**SUSITNA  
HYDROELECTRIC PROJECT**

FEDERAL ENERGY REGULATORY COMMISSION  
PROJECT No. 7114

**ALASKA POWER AUTHORITY  
COMMENTS  
ON THE  
FEDERAL ENERGY REGULATORY COMMISSION  
DRAFT ENVIRONMENTAL IMPACT STATEMENT  
OF MAY 1984**

**VOLUME 2B  
TECHNICAL COMMENTS  
-AQUATIC RESOURCES**

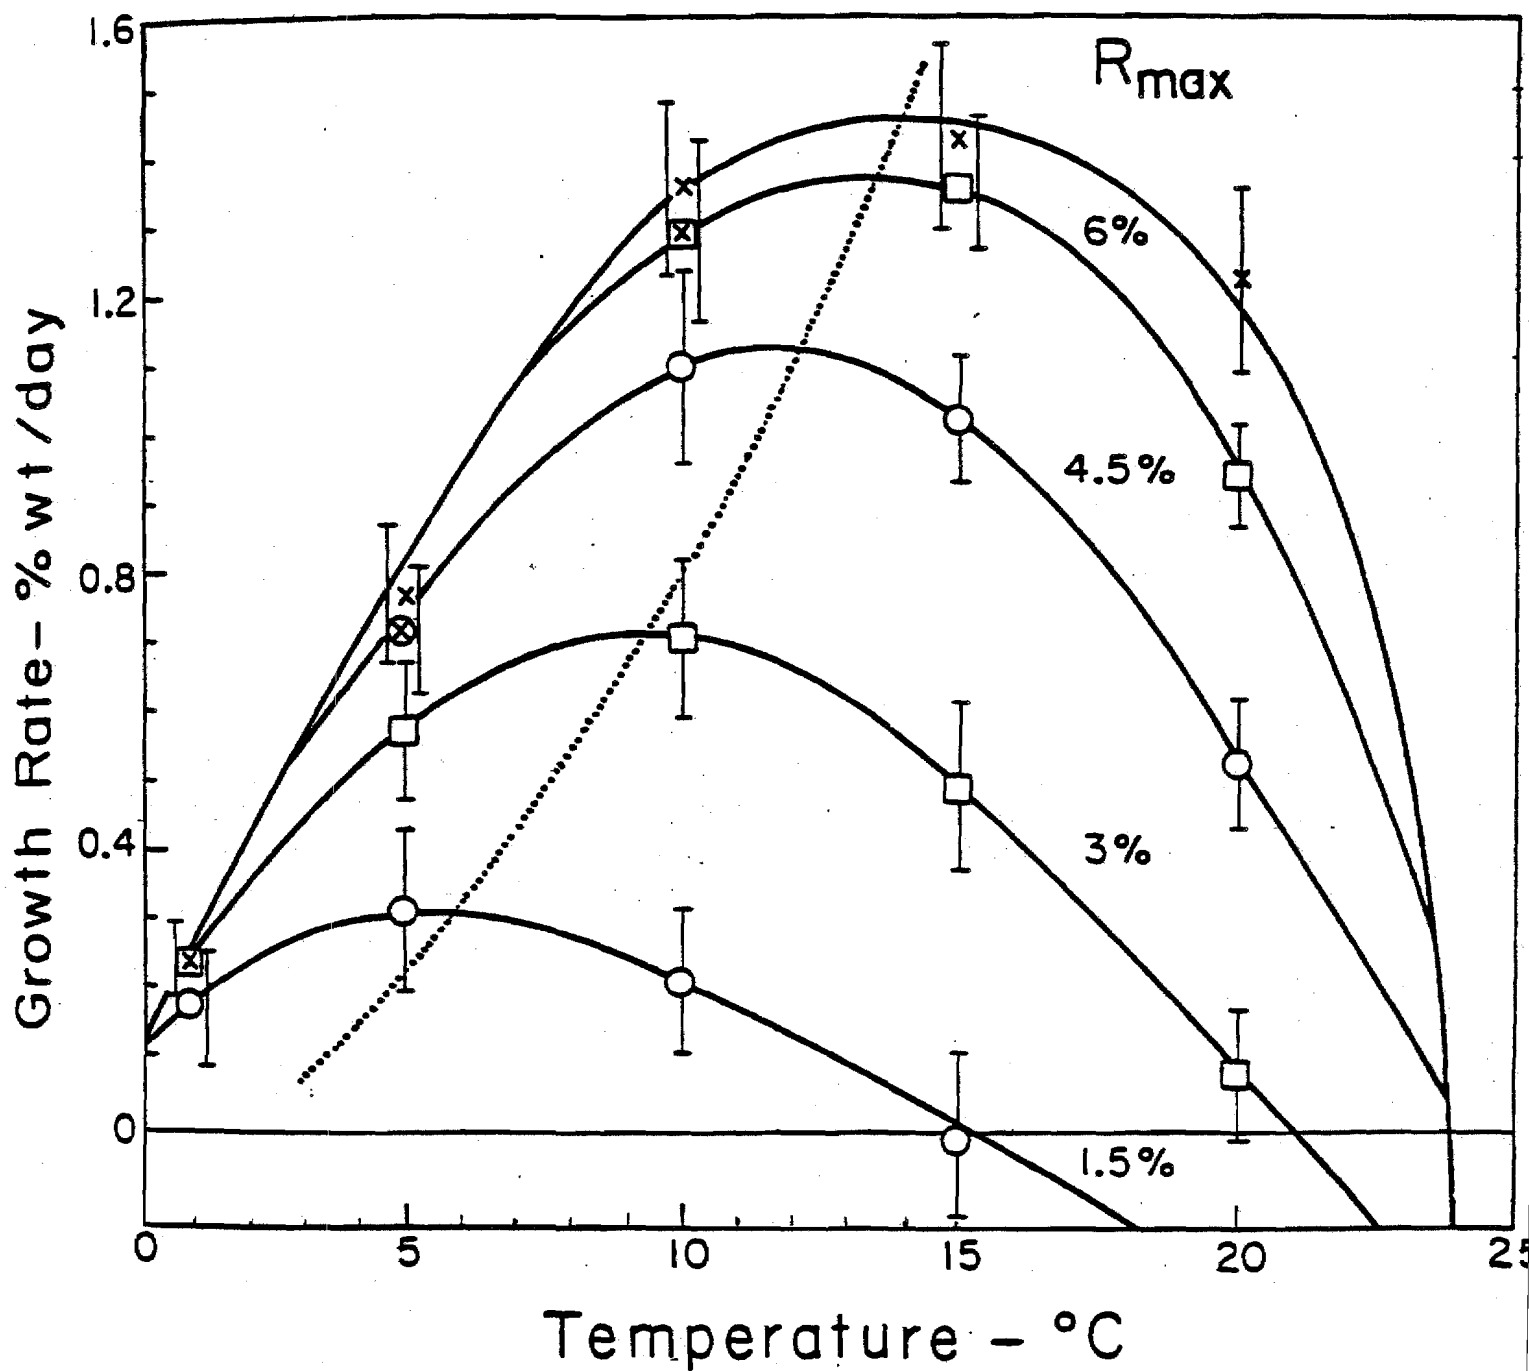
The effect of temperature on growth is a function of ration level (Figure 2, attached). For juvenile sockeye, the optimum temperature for growth decreased progressively from about 15°C at maximum rations to about 5°C at a ration size just above the maintenance ration (Brett, et al., 1969). A similar relation was found for brown trout with a decrease from about 13°C at rations close to the maintenance level (Elliott 1975). Changes in temperature result in relatively smaller changes in growth at reduced rations compared to maximum rations because of differences in the shape of ration versus growth relation. Consequently small drops in temperature during midsummer from 10°-11°C to 8°-9°C (Table 1, July and August) will result in relatively small changes in growth for fish feeding at reduced ration levels (Fig. 1). Since fish in the Susitna River are feeding on a low ration level, the expected changes in growth due to temperature reductions would likely be smaller than predicted in Tables 2, 3, and 4.
